Product Change Bulletin

5-14-2011

TR, 48

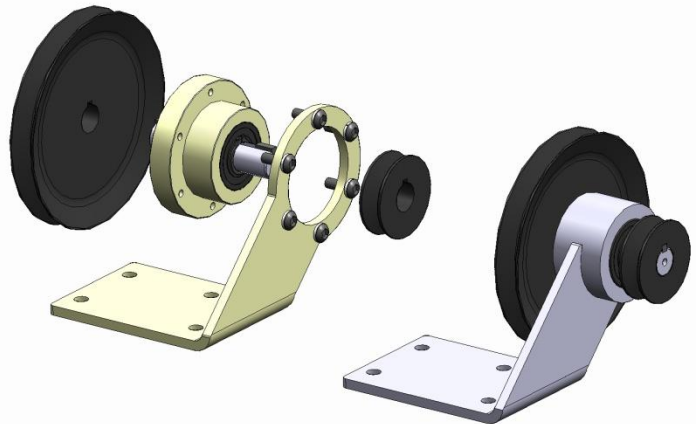
Warped tube that houses the bearings
causing failure

The new design eliminates the weld that could warp the machined tube which contains the bearings. We also made changes to the bearing tube to use 2 instead of 3 bearings and improved engagement between the shaft and the bearings "id". This will increase life expectancy and simplify service.

If the jackshaft has a welded tube that houses the bearings, this is the old part.

349-6280C

This is a direct replacement of the old jackshaft. Open hood to have access to the jackshaft. Remove broom belt from jackshaft's smaller pulley. Find the 5/16" bolts on the motor bracket and loosen them to have some play in the belt from the motor to jackshaft, pull motor towards seat to accomplish this. Loosen the pulley on the motor shaft with a 5/32" allen wrench. Loosen and remove the (4) 5/16" bolts holding the jackshaft onto the frame. Replace with new jackshaft, add the (4) 5/16" bolts, lock washers, and washers, tighten. Put the belt between the motor shaft and jackshaft back on. Align the belt as best you can between the 2 pulleys straight, but do not tighten the set screw yet. Push the motor towards the batteries to make belt tight. While still holding the motor back, tighten 2 of the motor bracket bolts. After 2 are tight you can stop pushing the motor and tighten the remaining 2. Eye ball the belt again and align as straight as you can. Tighten set screw. Put broom belt back on to smaller pulley.
